Application Number: 10/076,716
Filing Date: February 14, 2002
Appellant(s): YOUNG ET AL.

EXAMINER'S ANSWER

Claims 1,2,4,5,14-16,46-48 are rejected under 35 U.S.C. 102(b) as being anticipated by Smith et al (6046897).

**FIG. 9**

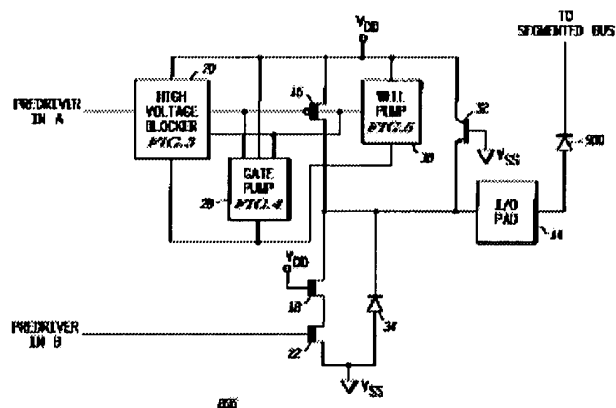
1,46) Bus lines BUS1,BUS2. Pad 14 connected to source, drain via 32,34. Figure 9 illustrates isolation diode 900. Charge pump 810,816.

2,28) Diodes 810,816 precharge higher than 3.3 V.

4,5,) Diode 900.

FIG. 8

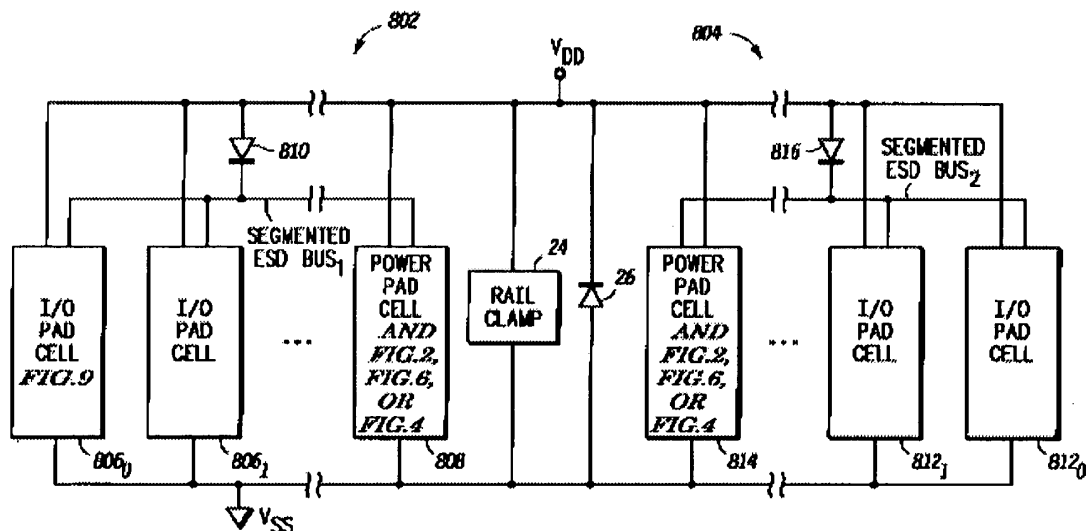
In reference to Smith et al, figures 8,9 which illustrate elements 810,816

Column 13, lines 13-20 clearly state the operation of the elements 810,816 as precharging the segmented ESD buses during normal operation.

Col. 13, lines 20-30 state the ESD is discharged to VDD, in the embodiment of a large positive voltage with respect to VDD, through VSS and diode 26, thus indicating 810,816 are not forward biased. Other embodiments such as an event below VSS (lines 53-65) are also discussed.

Column 13, lines 13-20, the operation of the elements 810,816 as precharging the segmented ESD buses during normal operation.

Smith et al further states the environment by stating that the I/O pads are prevented from seeing a capacitive load of the segmented ESD buses by the use of the precharging (lines 14-16).
